Control of Emissions from Marine SI and Small SI Engines, Vessels, and Equipment

Summary and Analysis of Comments

Assessment and Standards Division
Office of Transportation and Air Quality
U.S. Environmental Protection Agency

1.8.6 Field-testing demonstration for constant-speed engines

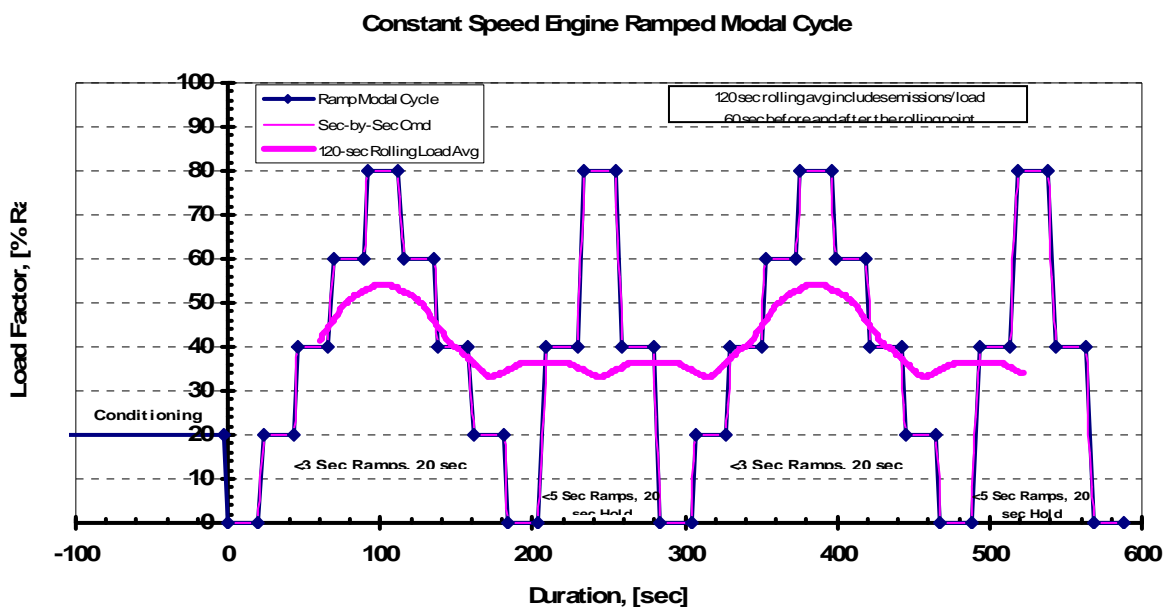
Intertek/Carnot recommended an approach to demonstrating for certification that constant-speed engines meet the field-testing standards. We requested comment on this because there is no longer a transient test requirement for constant-speed engines. The recommended testing involves ten minutes of engine operation consisting of steady operation for 20 seconds under several different load conditions. The test would be run like a ramped-modal cycle, except that the transitions between modes would last three seconds for increasing engine load in 20-percent increments and they would last five seconds for increasing load in 40-percent increments. The cycle does not include operation at full load, since spark-ignition engines generally don't operate for an extended time at full load. See the figure below for the detailed sequence of engine loads.
